**Final  
After Action Report  
For  
North Lobe  
Dredging**

**New Bedford Harbor  
Superfund Site  
Operable Unit No. 1  
New Bedford, MA**

June 14, 2005  
2005-24-0028  
No Response Required

## North Lobe Dredging After Action Report Consolidated Response to Comments

**FIGURE 1-4**  
NEW BEDFORD HARBOR SUPERFUND SITE  
NEW BEDFORD, MASSACHUSETTS  
**SAWYER STREET  
FACILITIES**  
SCALE: AS SHOWN

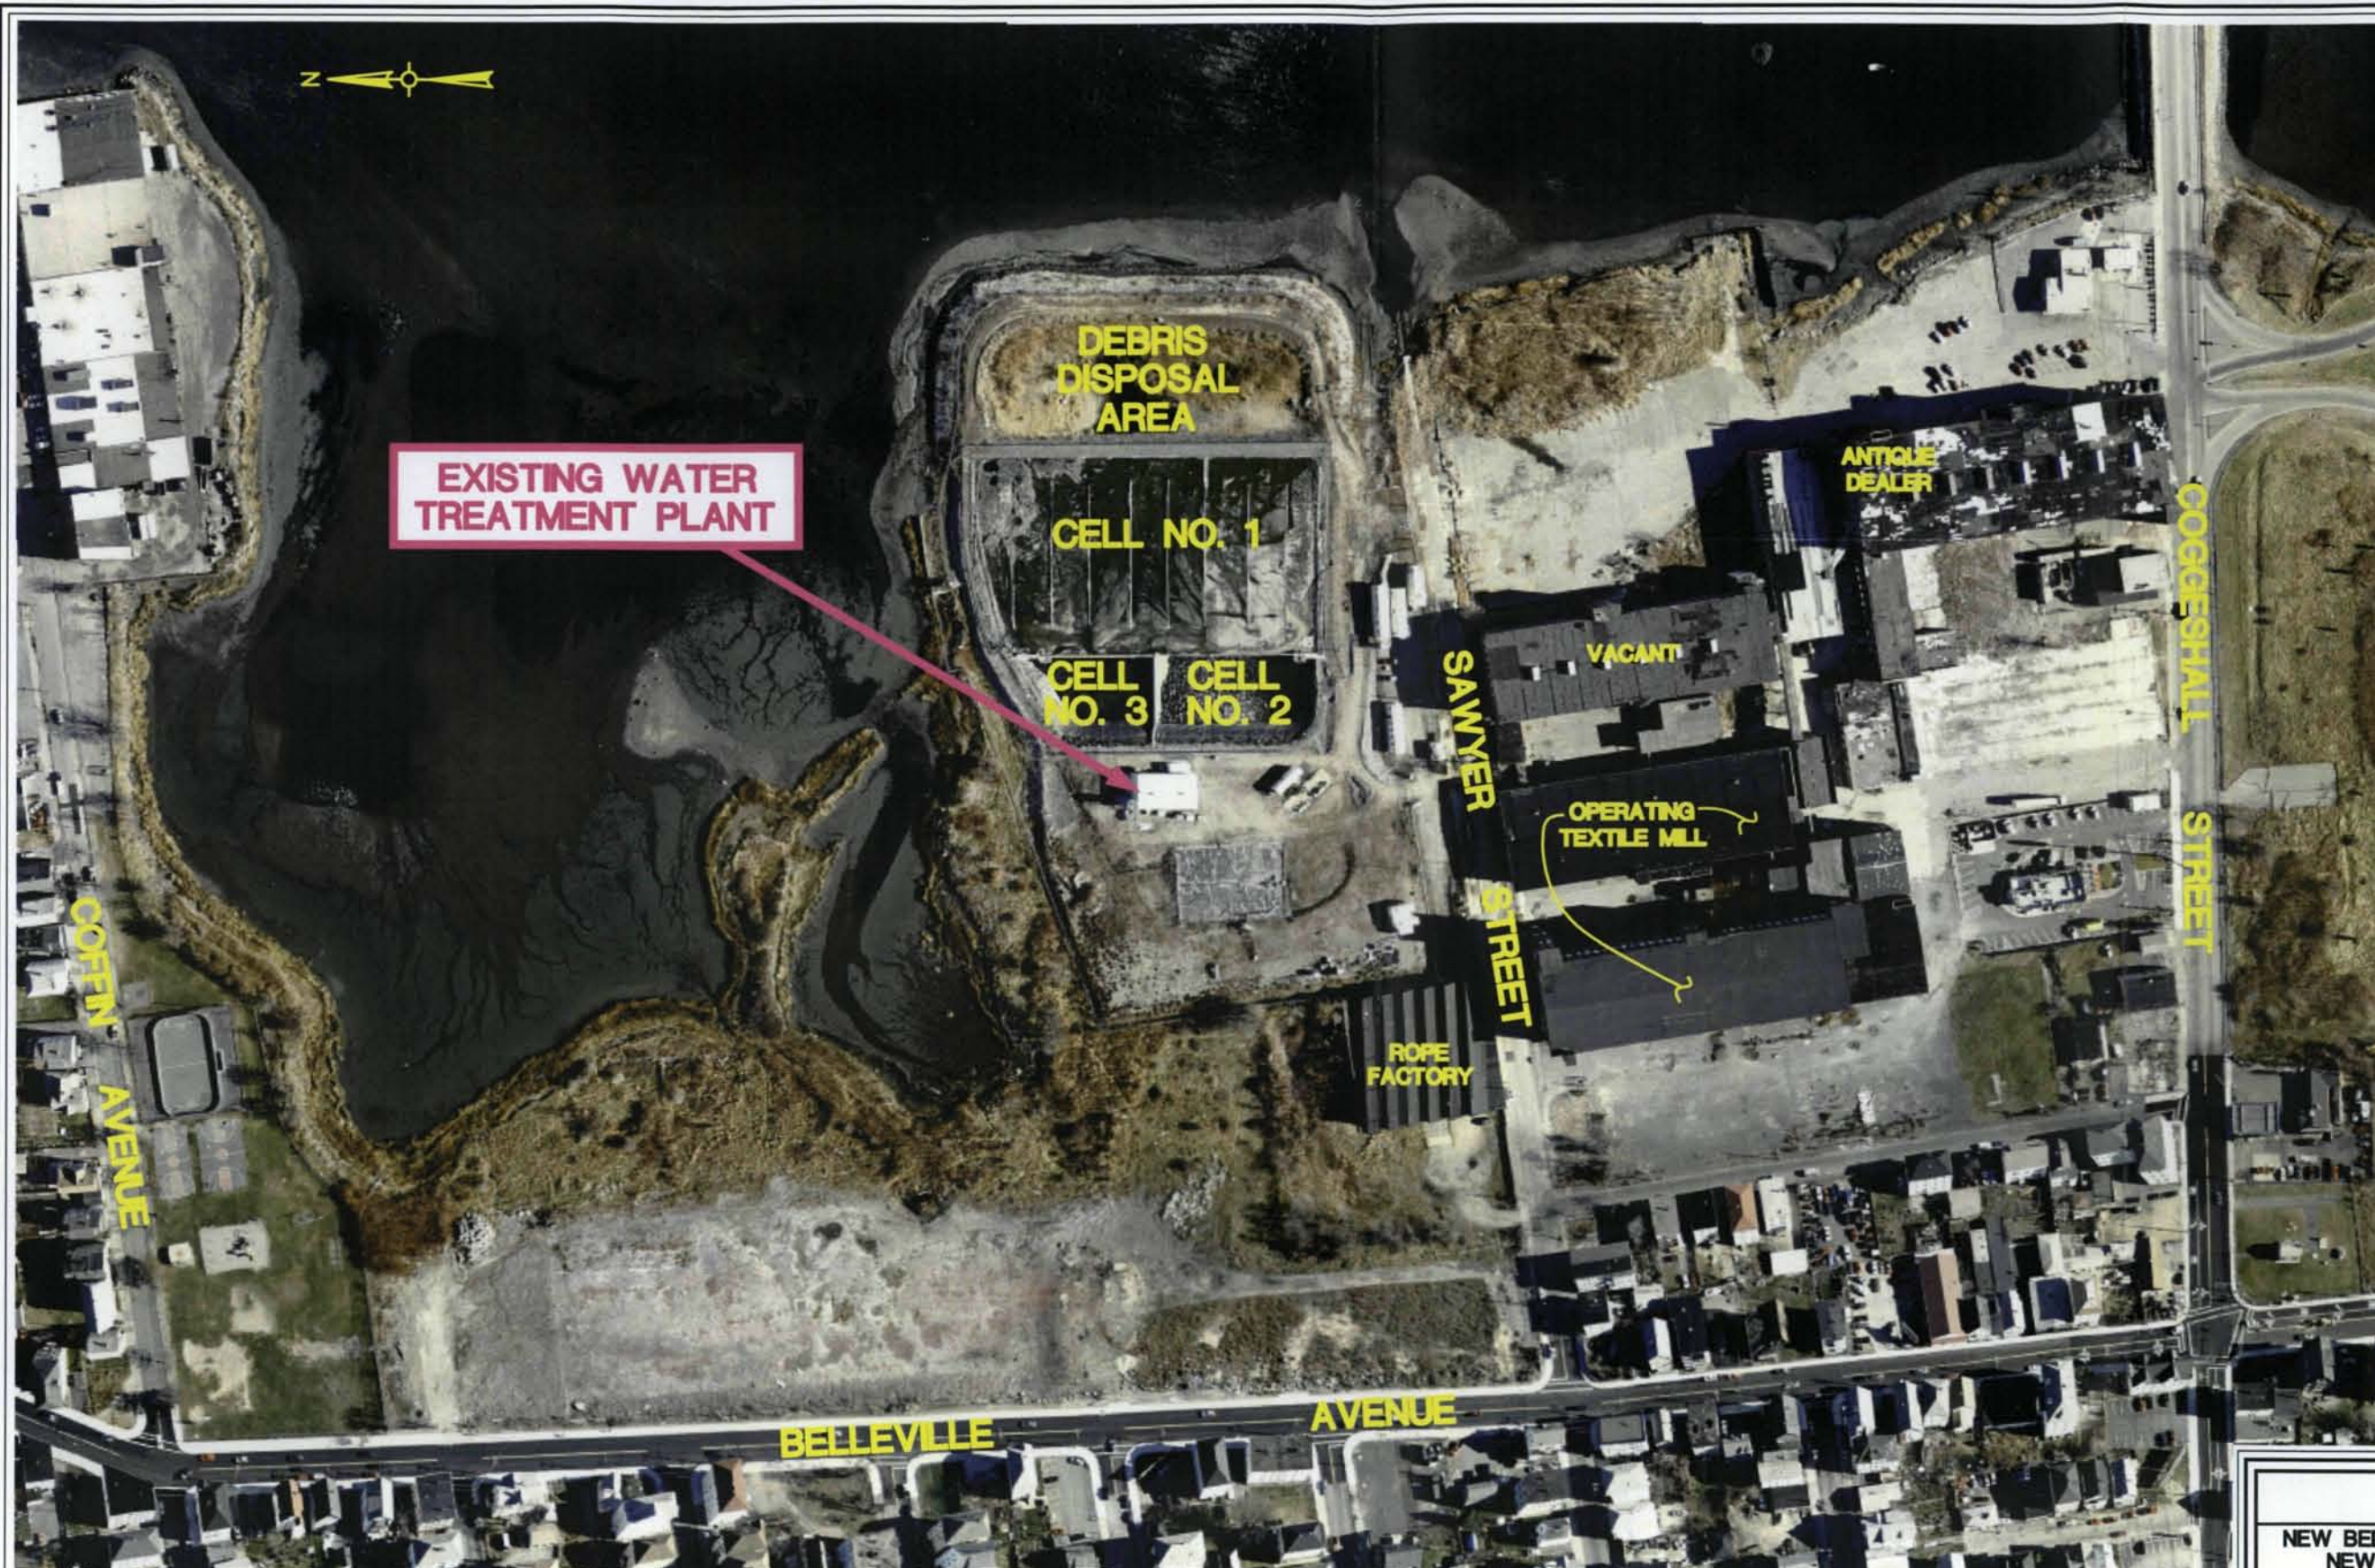
- \* Accepted.
- Page 1-2, 2<sup>nd</sup> para., last sent.: Figure 1-4 is labeled “Sawyer Street Facilities” in the Table of Contents which does not seem to fit this text reference. It is also not included.

- Figure 1-4 will be in final report. Text is added in Section 1.2 to provide explanation of the DDA and Cell No. 1 at Sawyer Street, and how these areas were used for processing/storing materials dredged from the North Lobe.

**FIGURE 4-1**  
**NEW BEDFORD HARBOR SUPERFUND SITE**  
**NEW BEDFORD, MASSACHUSETTS**  
**UPPER AND LOWER HARBOR**  
**AIR SAMPLING SITES**  
 FOSTER WHEELER ENVIRONMENTAL CORPORATION  
 TERC PROGRAM

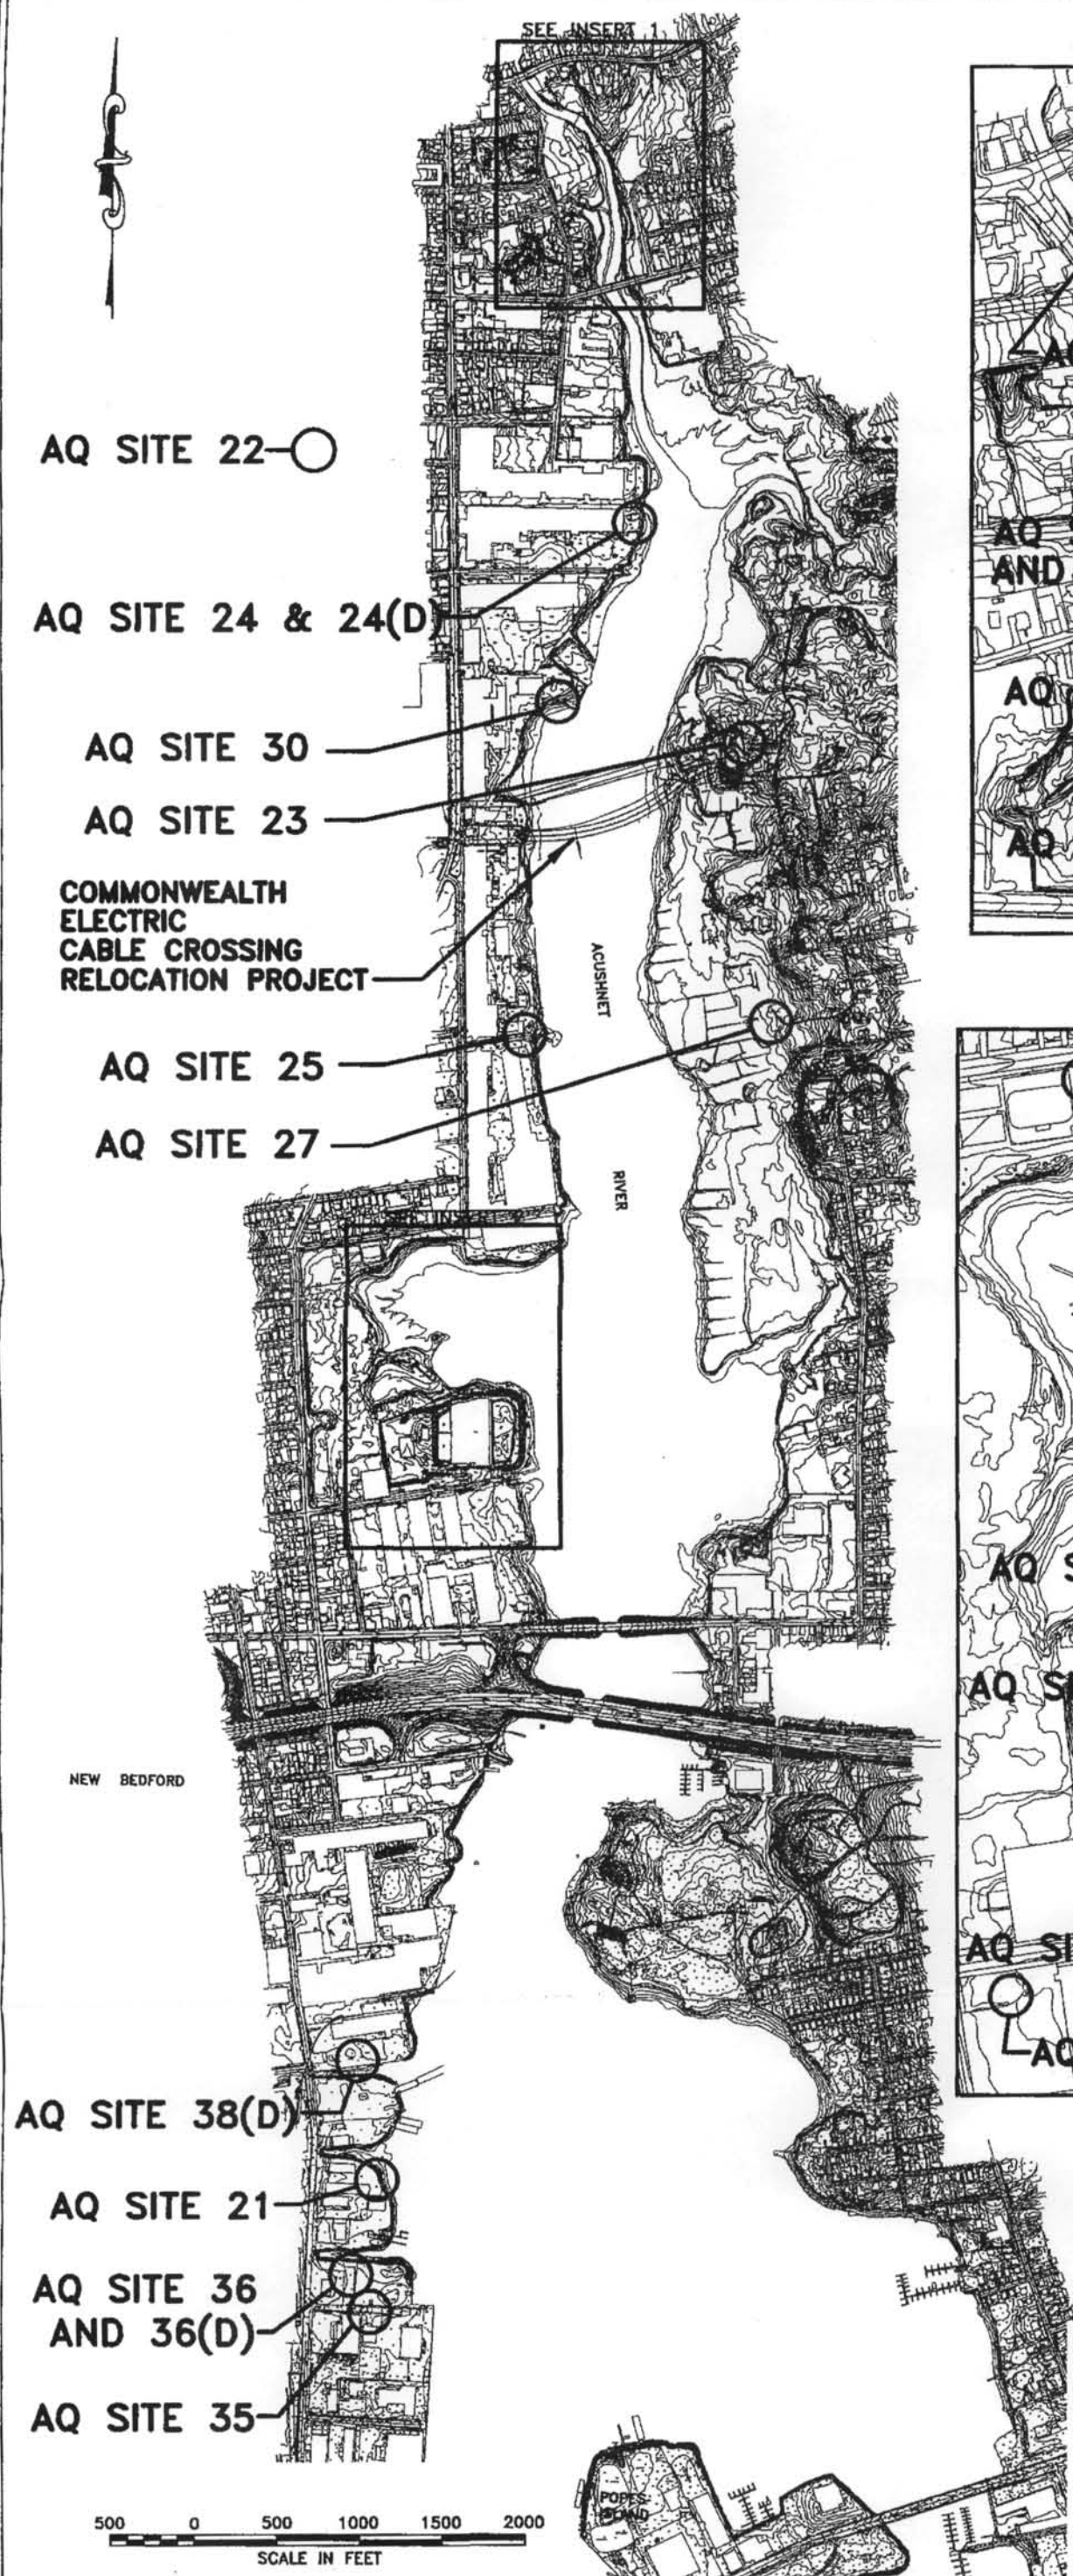
- \* Disagree. Transmittal numbers have not been included.
    - *Transmittal numbers have been included.*
- Page 4-4, section 4.9.1, 1<sup>st</sup> sent.: Figure 4-1 is not included.

- o Figure 4-1 is included in the updated draft report.
  - \* Accepted.
- Page 4-4, Section 4.9.1, 2<sup>nd</sup> para.: Delete the first sentence.
  - o Sentence was deleted.

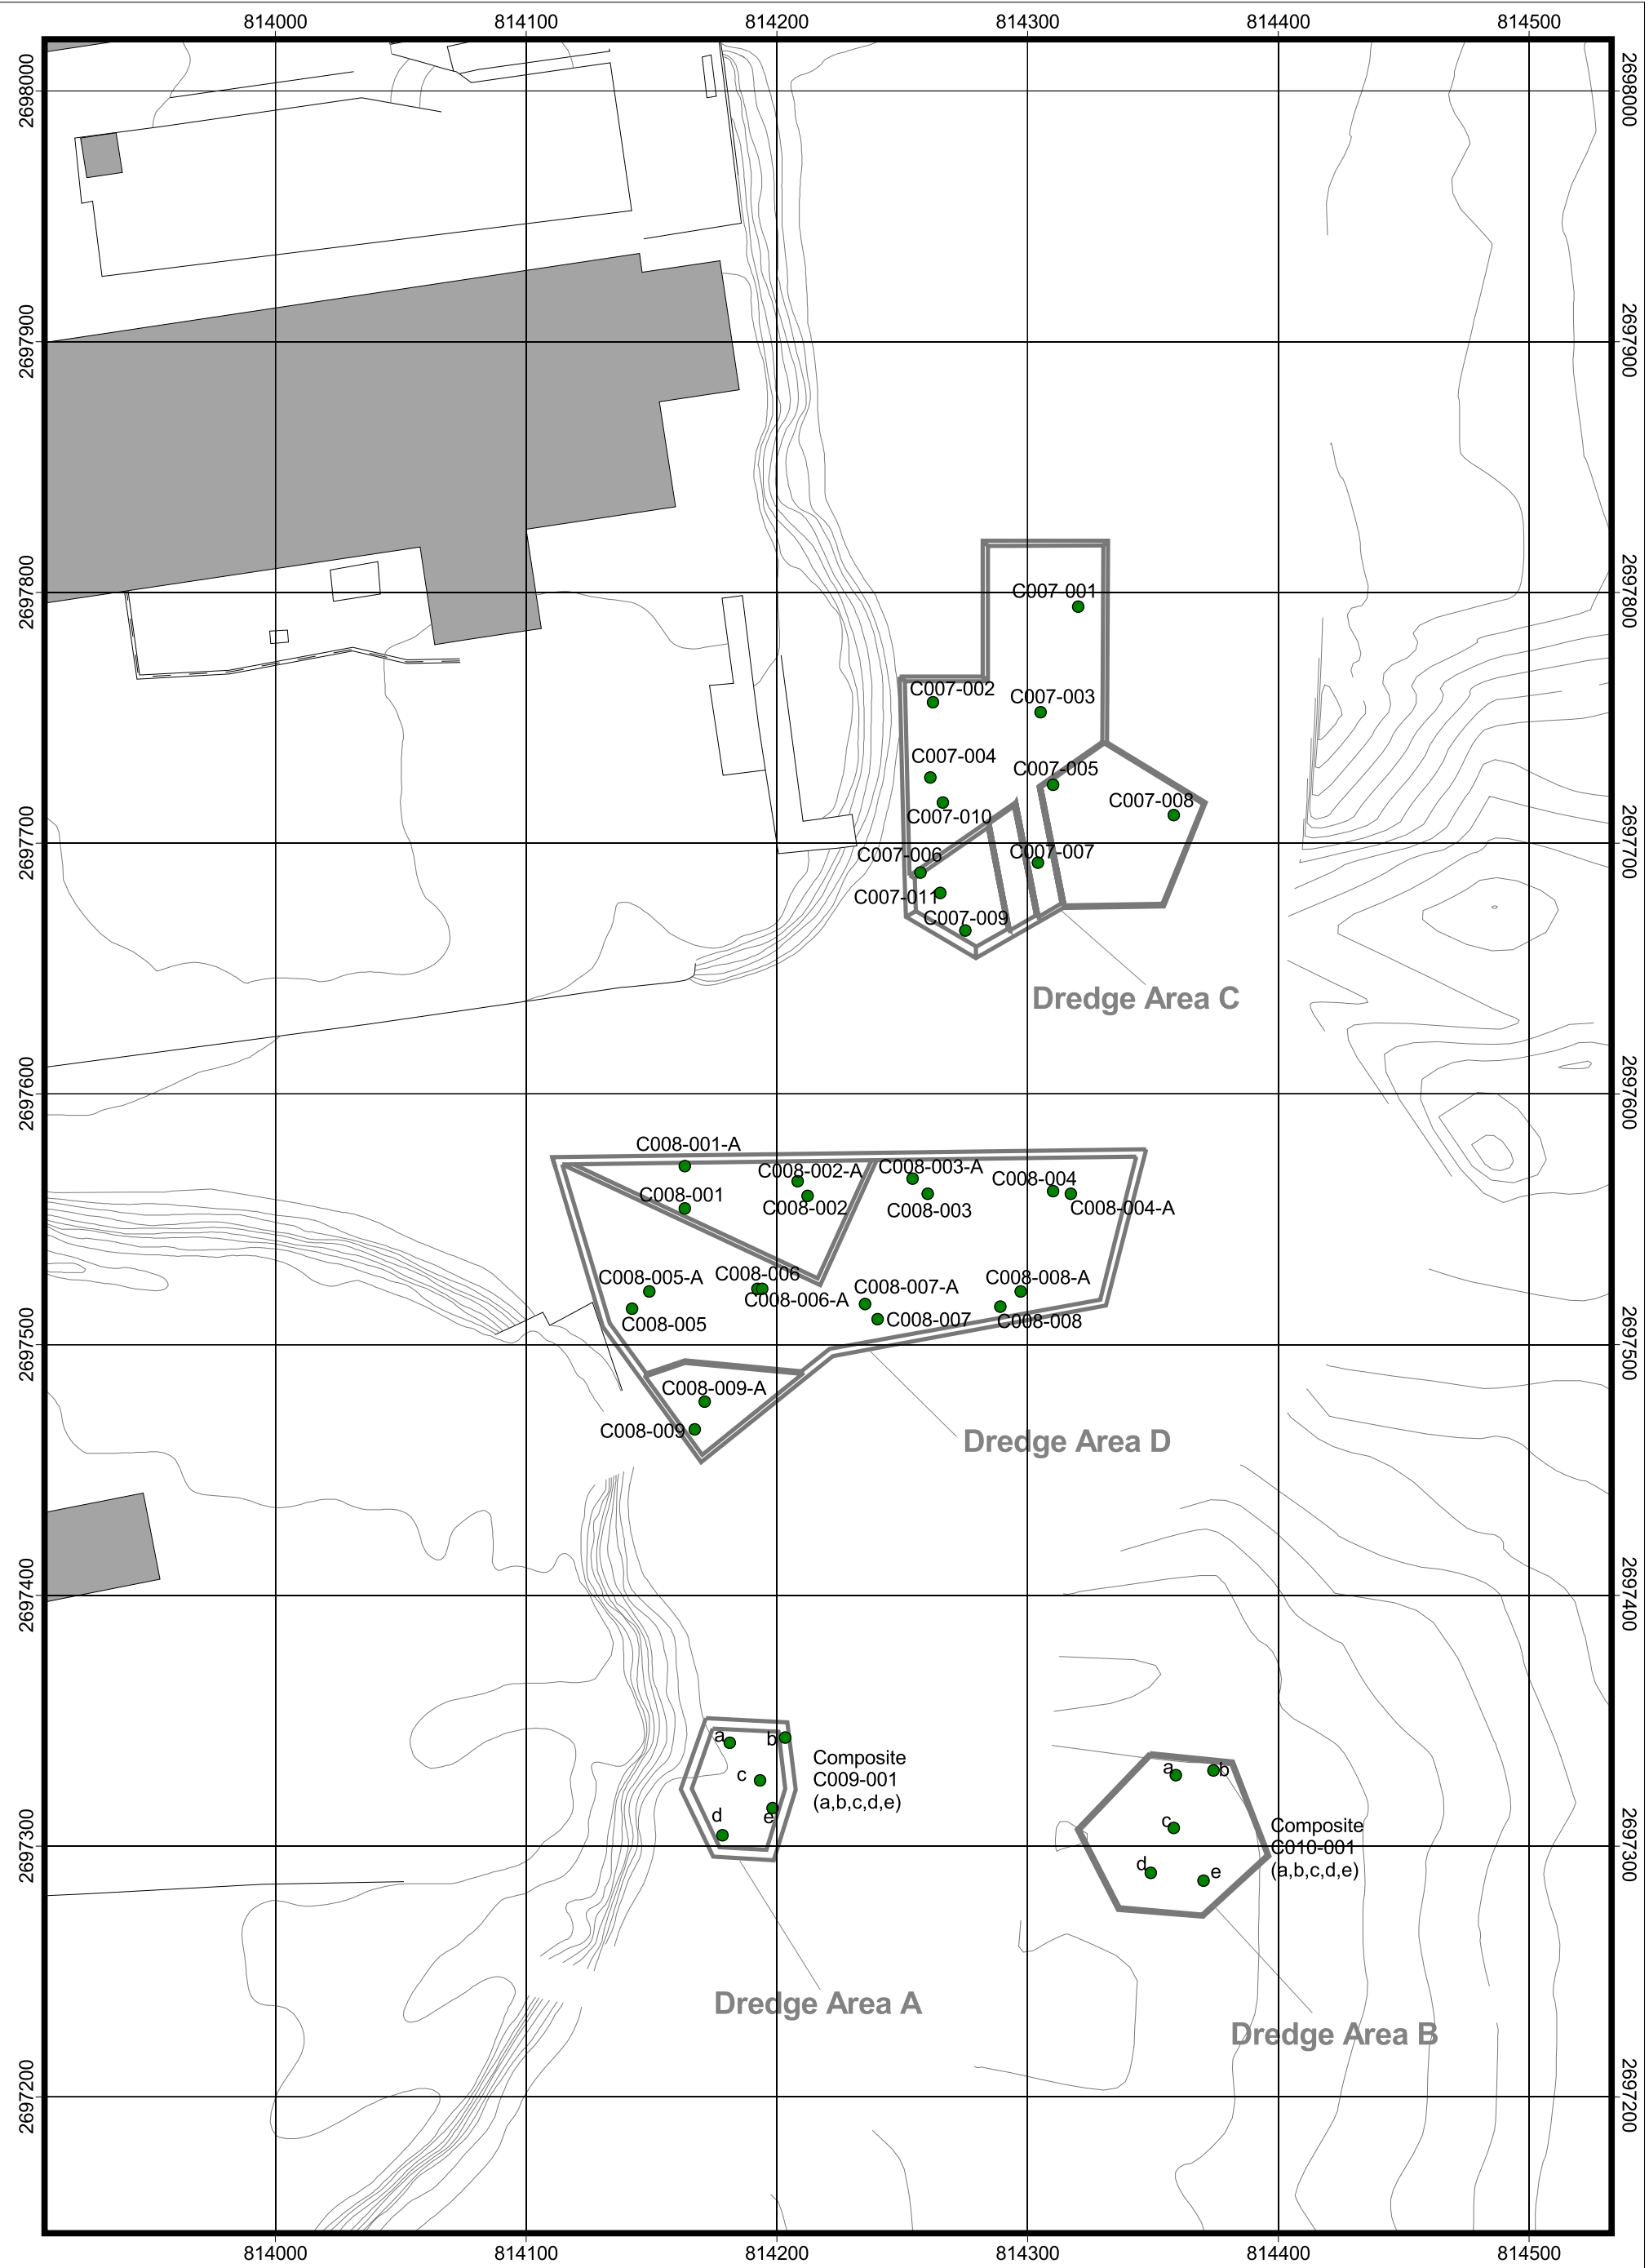
- Page 4-6, Section 4.9.2: In the title, change “Confirmation” to “Confirmatory”.
  - o Changes made as indicated.
  - \* Accepted.
- Page 4-6, Section 4.9.2, 2<sup>nd</sup> sent.: Figure 4-2 is not included.

- o Figure 4-2 was included in the updated draft report.
  - \* Accepted.
